Report: TAB REPORT
Function: Test, Adjust, & Balance
Date: 01/30/2026
Completed By: National TAB

PROJECT
01-26-26 WAWA #7219 LIMA, OH

Project: 01-26-26 WAWA #7219 LIMA, OH

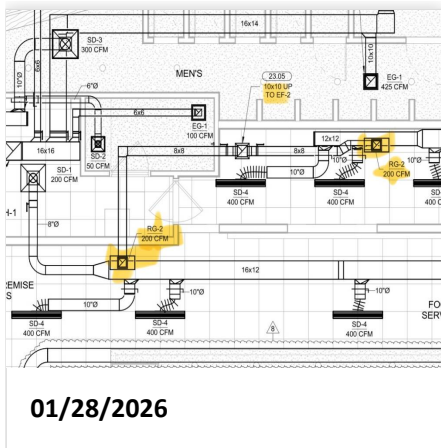
Issue Name : EF-2 LOW FLOW
Description : EF-2 is exhausting 120cfm out of 400cfm required by design. Low exhaust grille readings likely due to detached ductwork pictured.
Created By : National TAB **Assigned To :** National TAB - Noah Stafford
Status : Closed
Priority : High **Asset Tag :**
Originated Date : 01/29/2026 - Noah Stafford - National TAB

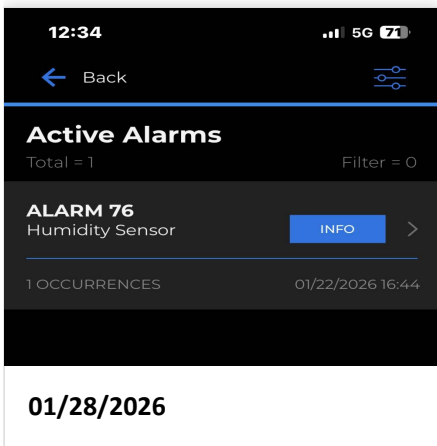
Issue Name : RTU-1 RETURN DUCTWORK
Description : Return grill 1-3 disconnected. Return grill 1-2 not ducted. TAB cannot be completed until resolved.
Created By : National TAB **Assigned To :** National TAB - Noah Stafford
Status : Closed
Priority : Urgent **Asset Tag :**
Originated Date : 01/27/2026 - Noah Stafford - National TAB

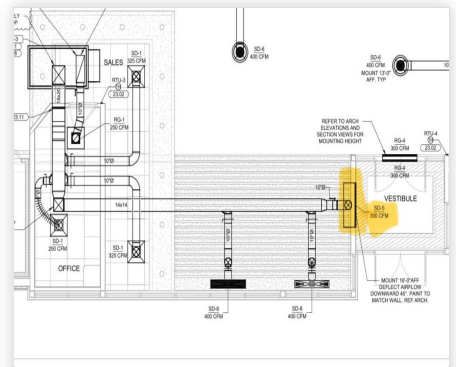
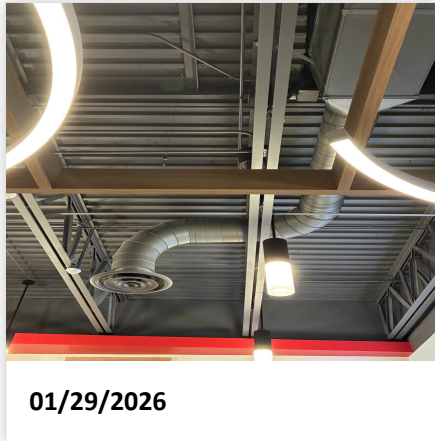
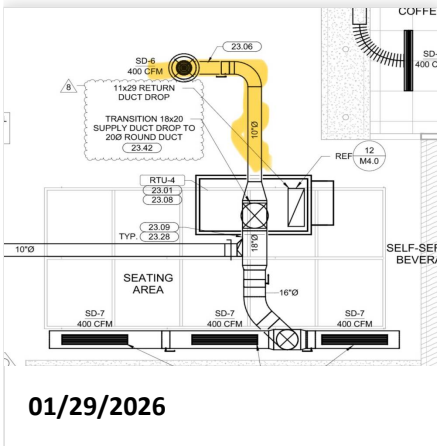
Issue Name : RTU-3 MISSING DIFFUSER
Description : RTU-3 is missing diffuser 3-1 at the main entrance vestibule. TAB cannot be completed until installed.
Created By : National TAB **Assigned To :** National TAB - Noah Stafford
Status : Closed
Priority : Urgent **Asset Tag :**
Originated Date : 01/28/2026 - Noah Stafford - National TAB
